South Texas Project
Units 1 and 2
Docket Nos. STN 50-498, STN 50-499
Response to Request for Additional Information Regarding
Generic Letter 95-07, Dated December 16, 1999

Pursuant to the request for additional information referenced above, the South Texas Project provides the attached additional information regarding Generic Letter 95-07, "Pressure Locking and Thermal Binding of Safety-Related Power-Operated Gate Valves."

**South Texas Project
Units 1 and 2
Generic Letter 95-07
Response to Request for Additional Information**

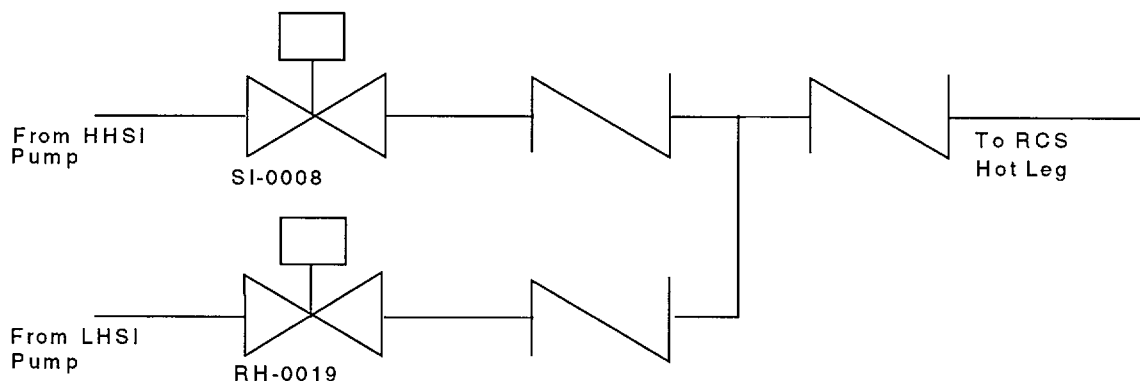
1. Justify use of the 23 psi/°F thermal-induced pressurization rate that was used in pressure locking calculations to determine maximum bonnet pressure for the high head safety injection hot leg isolation valves, 2N121XSI0008A/B/C and 2N122XSI0008A/B/C, the low head safety injection hot leg isolation valves, 1N161XRH0019A/B/C* and 1N162XRH0019A/B/C*, and the residual heat removal pump suction isolation valves 1R161XRH0060A/B/C, 1R162XRH0060A/B/C, 1R161XRH0061A/B/C, and 1R162XRH0061A/B/C. Your answer should include the basis for the Westinghouse determination that this is an acceptable thermal induced pressurization rate for use on Westinghouse valves. For example, your explanation should include any test data that was used to validate the 23 psi/°F thermal-induced pressurization rate.

A Westinghouse Owners Group industry survey of pressurization tests was the basis for the 23 psi/°F thermal-induced pressurization rate used in calculations to determine maximum bonnet pressure. The survey results show a wide range of values of thermal pressurization rates. Analysis of the data used the statistical method of geometric mean to reduce the impact of extreme values. The generic pressurization rate of 23 psi/°F was developed using the mean pressurization rate plus three times the standard deviation. These data show that this pressurization rate is valid as long as the temperature rise is no more than 70°F.

The test data from a Westinghouse valve were excluded from computation of the mean discussed above because the pressurization rate was too low; i.e., it would have resulted in undue bias in the non-conservative direction. Therefore, use of 23 psi/°F for Westinghouse valves is considered conservative. Previous discussions with the reviewer indicated that use of 23 psi/°F may be considered non-conservative with respect to general industry practice; however, the South Texas Project considers this value a prudent and conservative treatment for motor-operated valves having low risk significance.
